SERVICE BULLETIN

SERVICE BULLETIN NO: 71-007

**POWERPLANT
TORQUE OIL PRESSURE PIPE AND HOSE ASSEMBLIES - INSPECTION AND REPLACEMENT**

PC-12, PC-12/45 and PC-12/47 aircraft MSN 101 thru MSN 760.

Torque Oil-pressure Pipes and Py Pressure Pipes
 (Post-Service Bulletin 71-005 and 71-007)
 Figure 1 (Sheet 2 of 2)

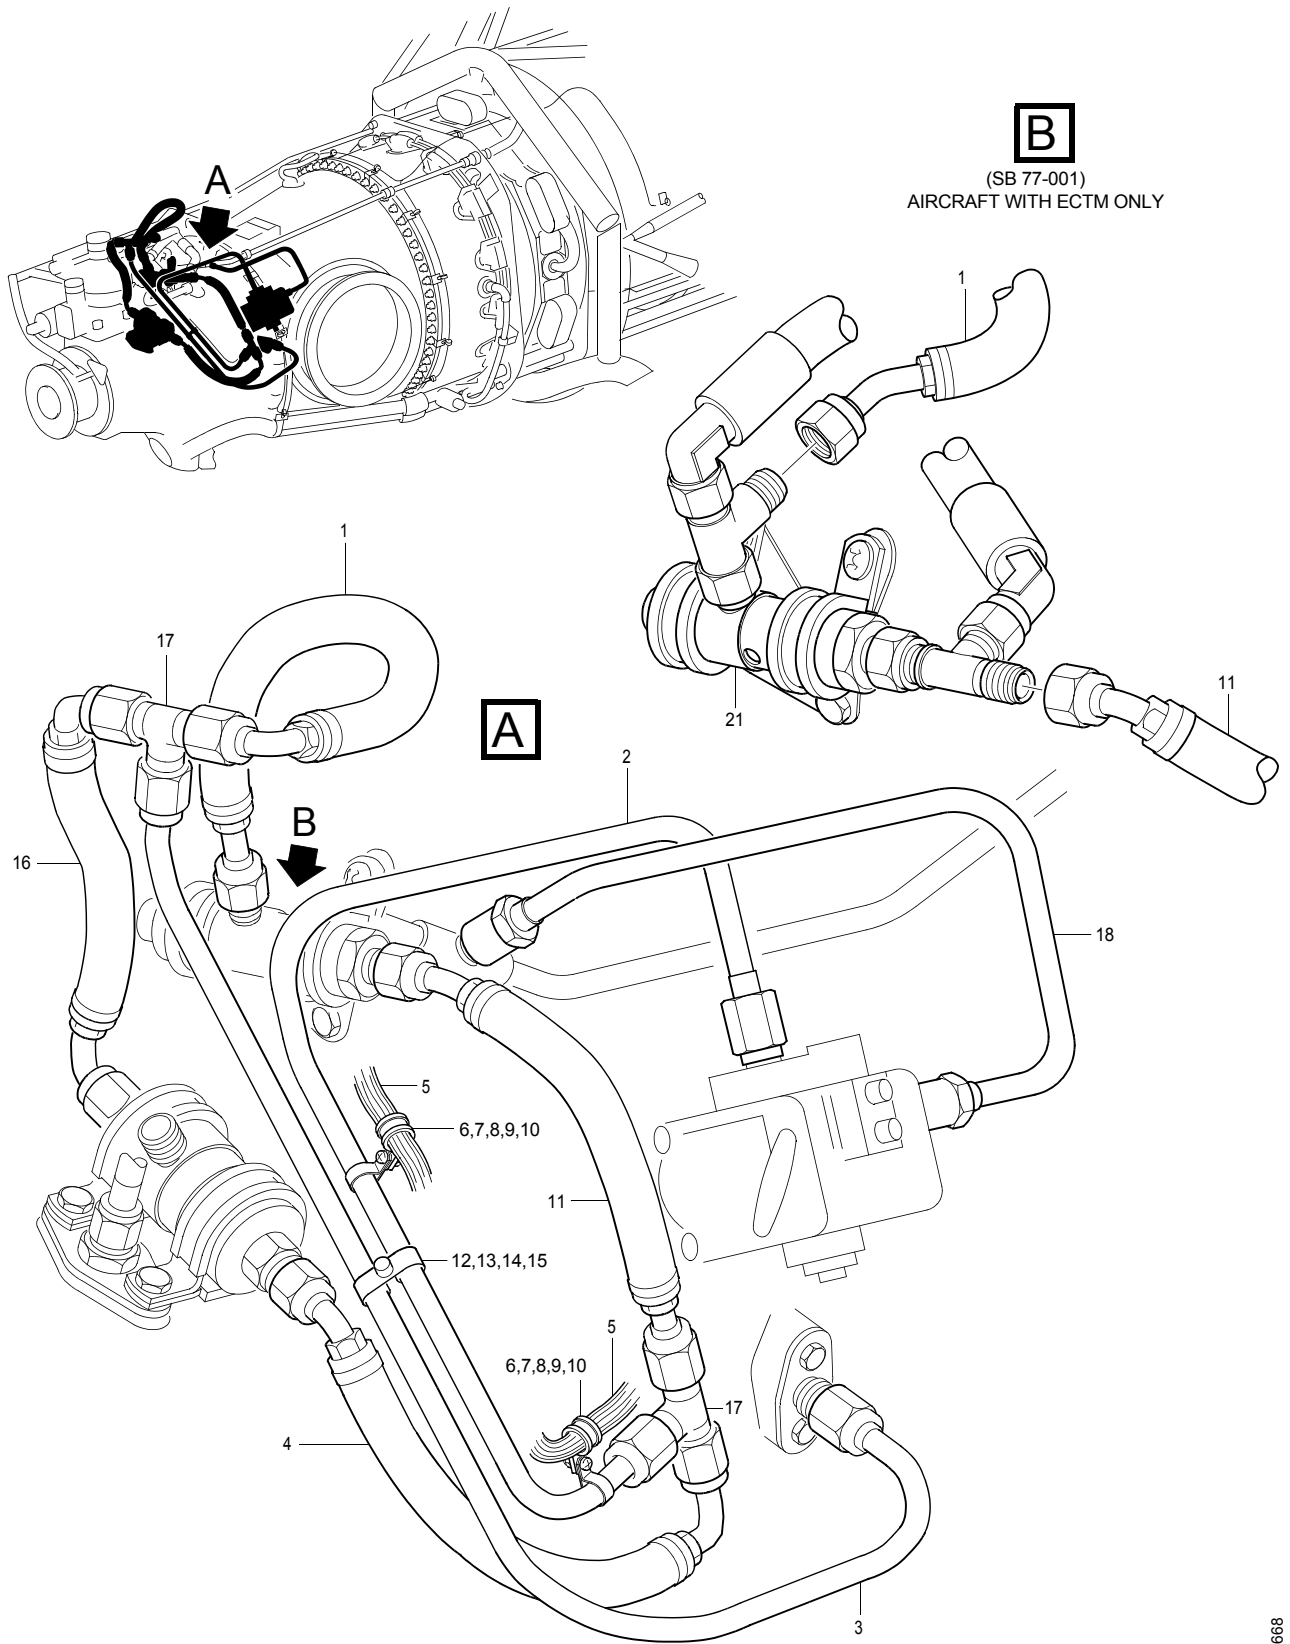
- (a) Disassemble remove and discard the hose assembly (Ref. Fig. 1, Sheet 2).
- (b) Loosely assemble the (new) hose assembly (4) on the differential pressure transducer (20) and TEE piece (17).

- (c) Tighten the union nuts at the ends of the hose assembly (4). Make sure the:
- Hose assembly is not twisted.
 - Clearance distances between the hose assembly and adjacent components are not less than 0.12 in. (3,0 mm).

- (3) Install the new pipe and hose assemblies (Ref. Fig. 1, Sheet 2).
- (a) Loosely assemble the (new) pipe assembly (3) and the hose assemblies (1) and (16) on one of the TEE pieces (17).

- (b) Loosely install the remaining ends of the:
- Pipe assembly (3) on the adaptor (19)
 - Hose assembly (16) on the differential pressure transducer (20)

- Hose assembly (1) on the torque transducer (21)
- (c) Loosely install one of the 90° unions (24) on the tail of the remaining TEE piece (17).
- (d) Loosely install the remaining 90° union (24) on the torque limiter (22).

- (e) Loosely assemble the pipe assembly (2) on the 90° union (24) (in the TEE piece (17)).
- (f) Loosely install the hose assemblies (4) and (11) on the TEE piece (17).

- Pipe assembly (2) on the on the 90° union (24) in the torque limiter (22)
 - Hose assembly (11) on the torque transducer (21)
 - Hose assembly (4) on the differential pressure transducer (20)
- (h) Loosely install the pipe assembly (24).
- (i) Loosely assemble the four clamps (14) and the two clamps (23) (together with the with the harness (5) on the pipe assemblies (2) and (3) at the positions shown. Do this together with the new screws (15), washers (13) and nuts (12).
- (j) Tighten the union nuts at the ends of the hose assemblies (1), (4), (11) & (16) and the pipes assemblies (2), (3) and (18). Make sure the:
- Hose assemblies are not twisted.
 - Clearance distances between the pipe/hose assemblies and adjacent components are not less than 0.12 in. (3,0 mm).
- (k) Tighten the nuts (12) to fully install the clamps (14) and (23).

Torque Oil-pressure Pipes and Py Pressure Pipes
 (Pre-Service Bulletin 71-005)
 Figure 1 (Sheet 1 of 2)

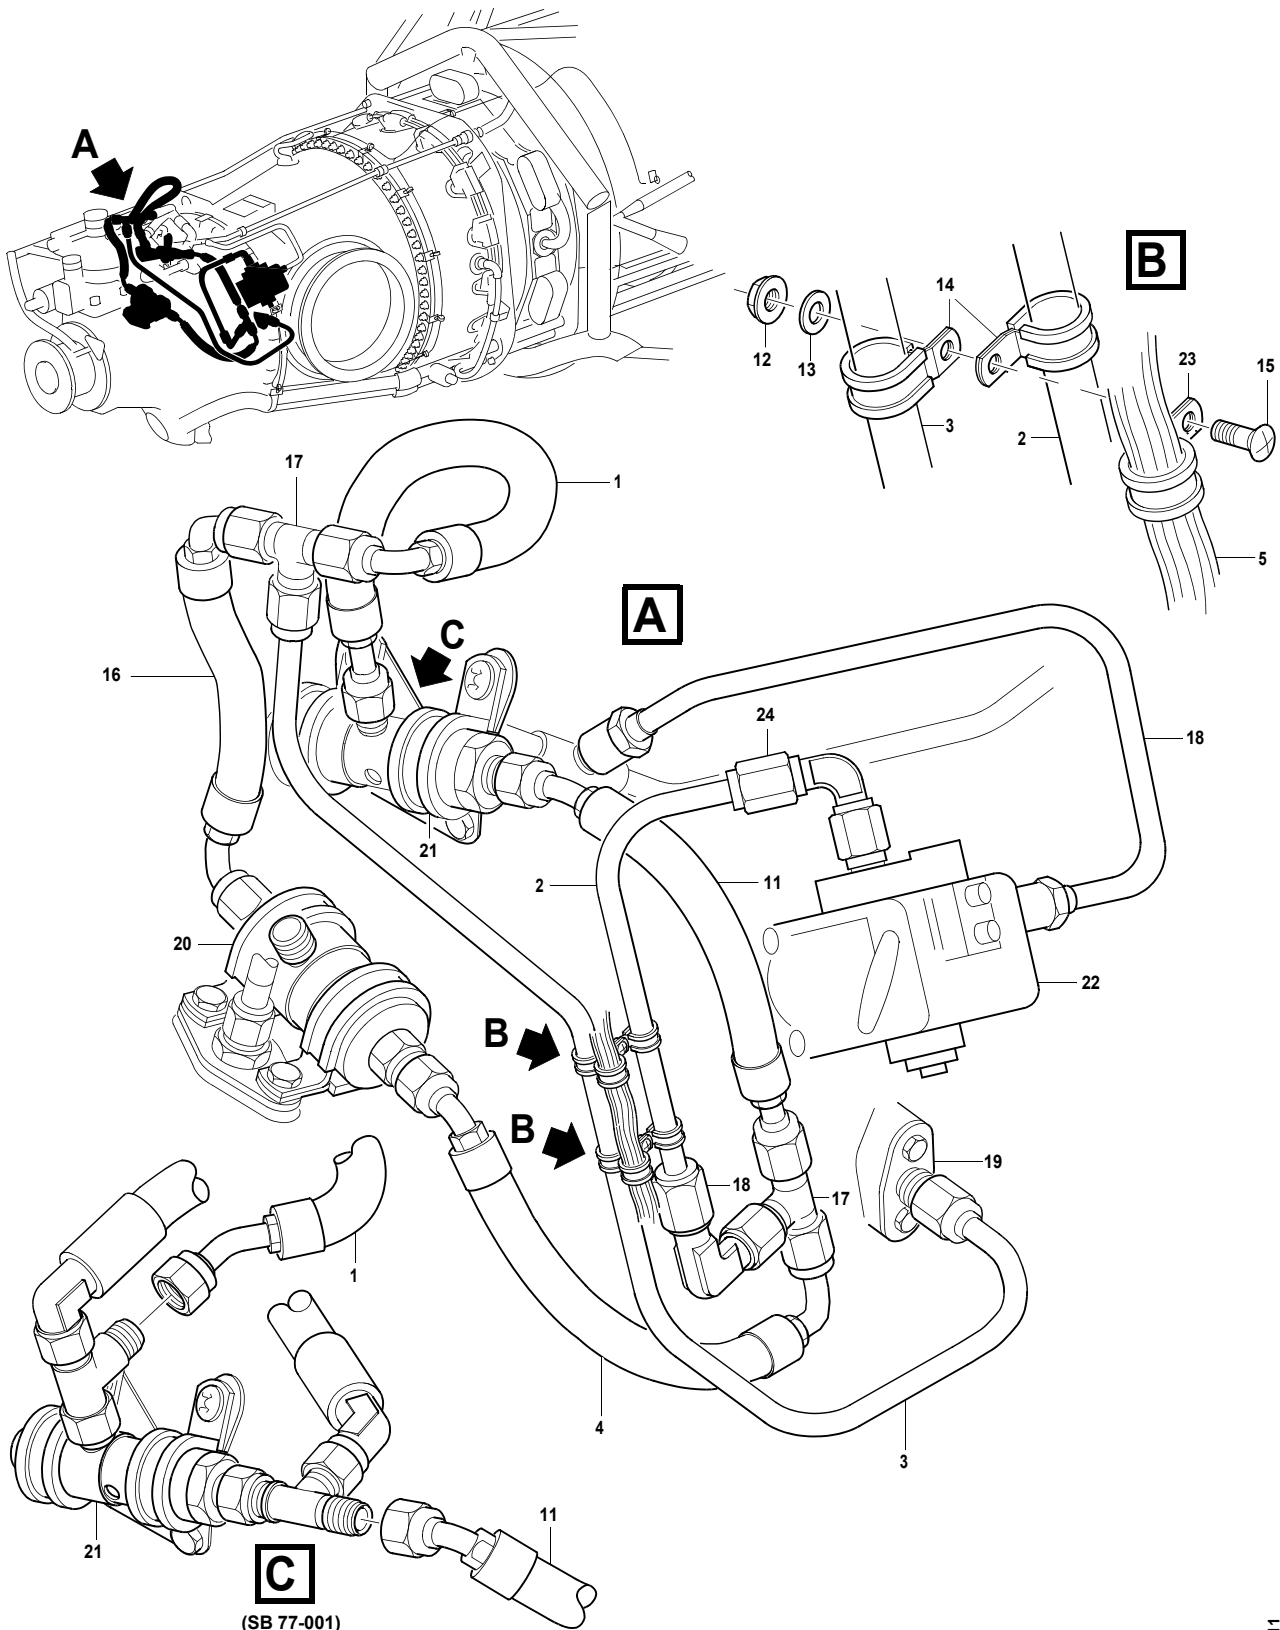
Chafing (abrasive) damage has occurred on oil pipe assemblies in the area of the oil pressure transducer on the engines of some PC-12 aircraft. The damage has caused engine oil leakage in some aircraft.

Pipes and/or the hoses have touched during engine operation. Incorrect assembly (after removal for inspection) has decreased the clearance distances between given pipe/hose assemblies and adjacent components.

- (2) Remove the pipe and hose assemblies (Ref. Fig. 1, Sheet 1). Steps (2) and (3) are applicable for the replacement of the pipe/hose assemblies in full compliance with this Service Bulletin (Ref. Sect 1, Para E, (2)).

- (a) Remove and discard the screws (6), nuts (7), washers (8), clamps (9) and clamps (10).
- (b) Remove and discard the nut (13), washer (14), screw (12), and clamps (15).

- (c) Remove and discard the pipe assemblies (2), (3) and (18), and the hose assemblies (1), (4), (11) and (16). Do not discard the two TEE pieces (17).

- (a) Do inspections for signs of abrasion damage. Defective pipe/hose assemblies must be replaced. The contours of the new pipe/hose assemblies will help to prevent abrasive damage.
- (b) Do checks to identify the configuration of pipe/hose assemblies in the given aircraft. Pre-Service Bulletin 71-007 pipe/hose assemblies must be replaced.
- (c) As a temporary option Operators can also:
 - Adjust serviceable Pre-Service Bulletin 71-007 pipe/hose assemblies to make sure that the clearance distances are sufficient
 - Replace defective pipe/hose assemblies with Pre-Service Bulletin 71-007 parts
